SUBJECT: Part 21 rept re 2"-1878 globe piston check valves. A/DV plans
 to include philosophy of both enhancement w/smaller piston
 check valves. A/DV evaluated found condition of piston check
 valve, stuck open.

Subject: A/DV 1878 Class Piston Check Valves

Subject: A/DV 2"-1878# Piston Check Valves

ANCHOR/DARLING VALVE COMPANY			
2"-1878 FULL PORT SOCKET ENDS STAINLESS STEEL PISTON CHECK VALVE NON-COBALT TRIM			
DWN BY: HLD	DATE: 9-23-92	DRAWING TYPE: CCA	REV: 1
CHK BY: BDK	DATE: 10-1-92	W: 9 2 2 3 8 7 0	A
APP'D BY: RFB	DATE: 10-19-92	1 2 3 4 5 6 7 8 9

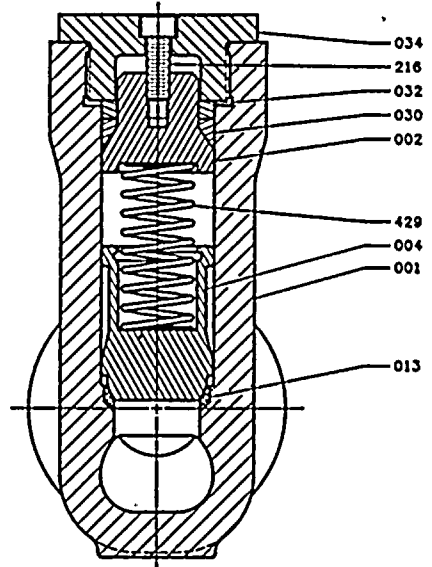
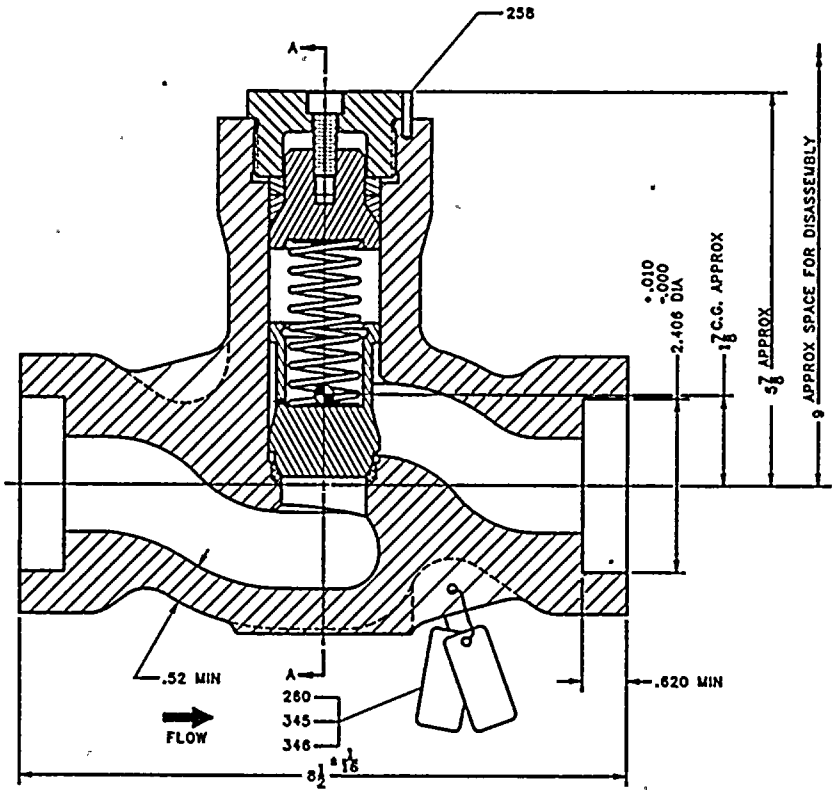
FP&L reported having difficulty in sealing the ADVanseal using the capscrew without pressure. The current capscrew is a 5/16" diameter capscrew. A 1/2" diameter capscrew will be used in the future. This will provide approximately three (3) times the gasket load.

FP&L has experienced galling of the bonnet retainer threads. The current retainer is made of 316 stainless steel with chrome plated 12 series threads. ADV is evaluating replacing this design with a 17-4PH bonnet retainer (no chrome plating) with 8 series threads. Assuming successful completion of the new bonnet retainer evaluation, this design will be put in place.

We evaluated this area to determine if the body guides could be improved. Several methods were evaluated, i.e., sleeving the body bore with hardened material, reshaping the exhaust port, etc. All methods are costly. The conclusion was reached that the above changes were cost prohibitive and the better resolution is to use a smaller valve for oscillating flow application in order to place the disc in a more open position where it is better guided by the body.

As a result of our evaluation of the FP&L failed valve and our testing, we have concluded that the root cause is the disc oscillation, caused by the reciprocating pump, causing fretting to take place in the valve body disc guide area. The fretting area provides a configuration in the body guide that allows the disc to stick open without forward flow and with reverse flow.

- A. Use of in-line check valves in reciprocating pump applications. This valve design provides better wear resistant materials as disc guides throughout the entire valve stroke.
- B. Use of smaller piston check valve (valve size or reduced port) in reciprocating pump applications to more fully open the disc where better body-disc guiding is available. Attached are graphs of flow rate versus disc position and Cv versus disc position to be used to evaluate T-pattern piston check valve size selection. Where a smaller T-pattern piston check valve produces too high a pressure drop, use of a Y-pattern piston check valve may resolve this concern.
